# DEVELOPMENT REVIEW BOARD REPORT

CASE NUMBER/ 37-DR-2004
PROJECT NAME The Portico

REQUEST Request site plan & elevations approval for an office/residential condominium

# Stipulations for Case: The Portico 37-DR-2004

**ATTACHMENT #4**

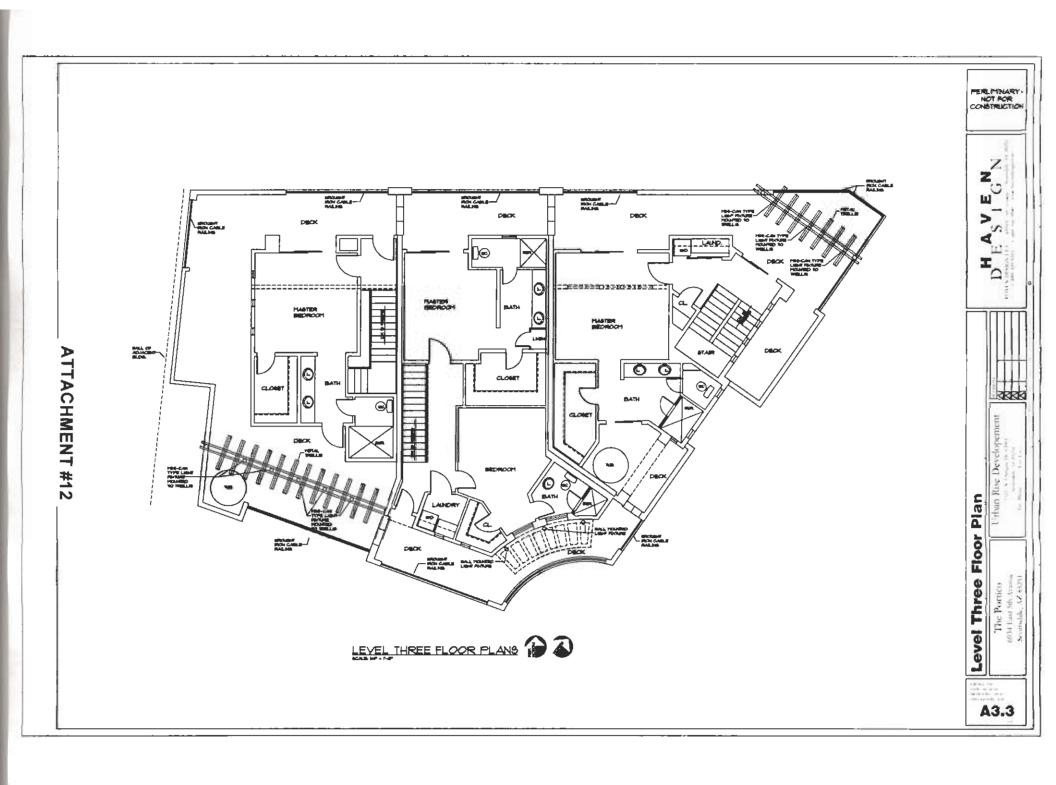
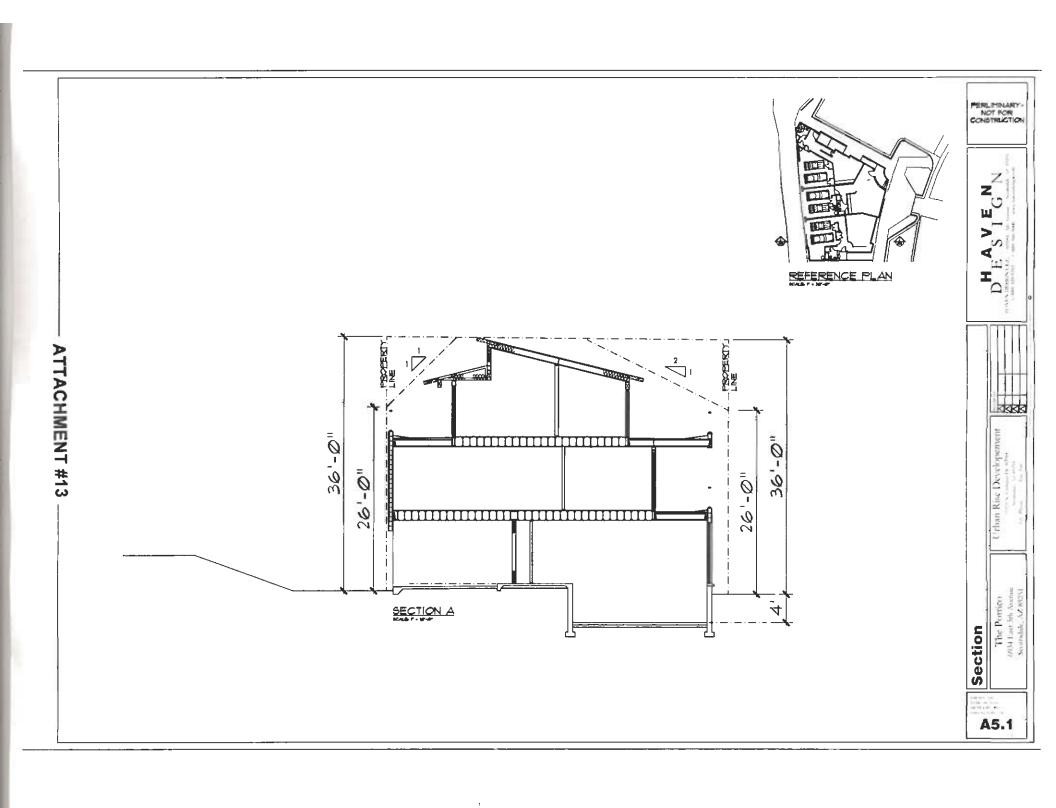
- 21. Provide a cross access easement at the northeast corner of the property with adjacent property to the east.
- 22. Provide a written approval from Fire Department not requiring additional alley easement to be dedicated.
